**ACCESSIBILITY SELF-EVALUATION AND TRANSITION
PLAN
SANTA MONICA MOUNTAINS NATIONAL RECREATION
AREA
CALIFORNIA**

NOVEMBER 2022

05**Picnic Facilities**

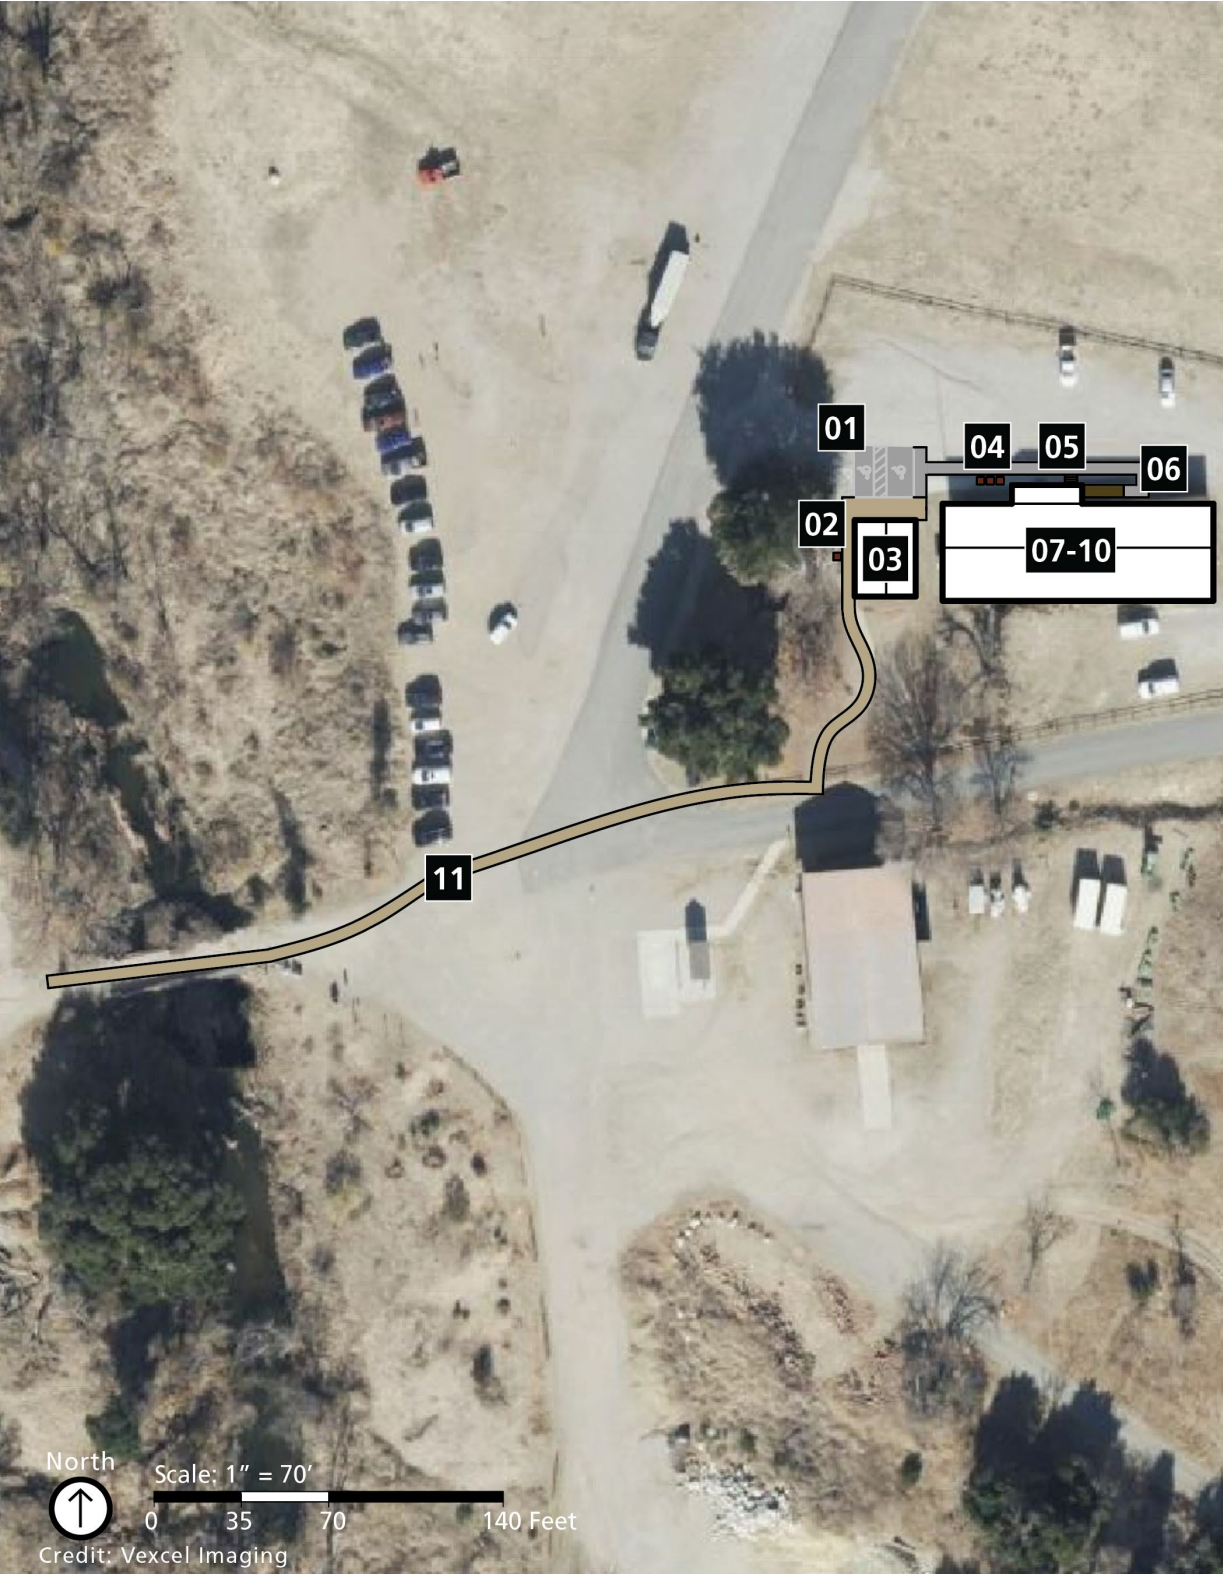
- 1) Replace 20%, but no less than two, of picnic tables to be accessible. The tables shall have an extended section or a bench cut out with appropriate knee and toe clearance. Secure tables to a surface with a slope no greater than 2% in all directions. Provide 36" minimum width clear ground space on all usable sides of accessible tables. Ensure the accessible table is connected via an outdoor recreation access route to the accessible parking stall.

09 Benches

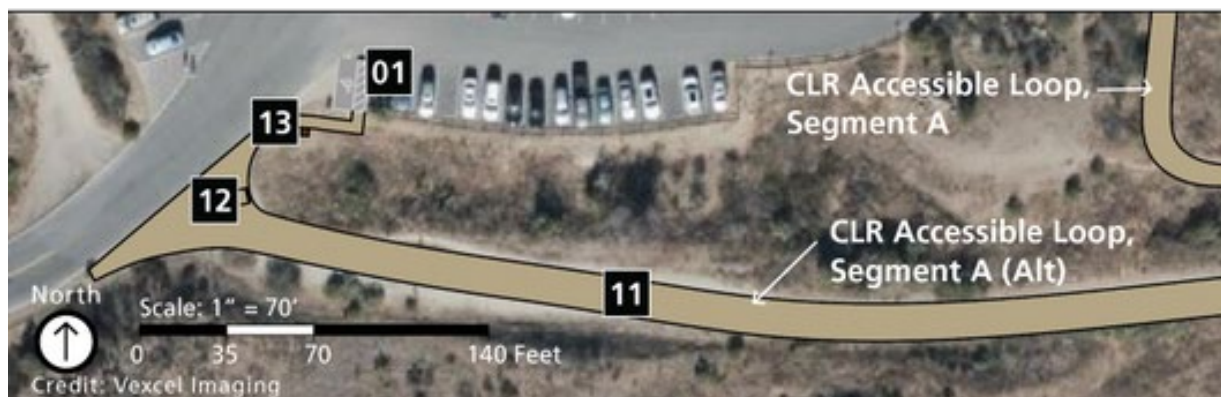
- 1) Although not required, as a best practice, provide a bench at the dam for visitors to enjoy the view. As a best practice, provide a backrest and an armrest on at least on end of the bench and a wheelchair space adjacent to the bench that is 36" minimum in width and 48" minimum in depth with a 2% maximum slope in all directions.
